NUMBER: 23-015-18

GROUP: 23 - Body

Headlamp Condensation and Fogging

This bulletin involves installing updated vent caps on the headlamp assembly.

Fig. 3
Location Of Vent Caps

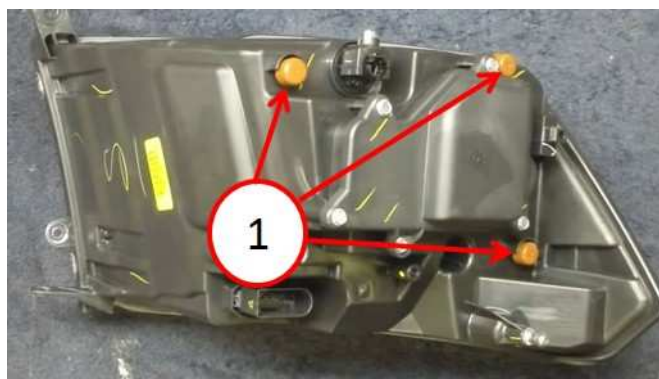
1. Remove the headlamp assemblies. Refer to the detailed service procedures available in DealerCONNECT> TechCONNECT> 8L - Lamps and Lighting / Lamps/Lighting - Exterior / Unit, Front Lamp/Removal.
2. Remove and discard the old vent caps by pulling them rearward from the headlamp assembly ([Fig. 3](#)) .

3. Install the new (brown) vent caps by pushing them on the bosses of the headlamp assembly.
4. Install the headlamp assemblies. Refer to the detailed service procedures available in DealerCONNECT> TechCONNECT>08 - Electrical/8L - Lamps and Lighting/Lamps/Lighting - Exterior/Unit, Front Lamp/Installation.

Qty.	Part No.	Description
1 (AR)	68353620AA	Kit, Vent Caps (Brown) (One Kit Per Headlamp Assembly)
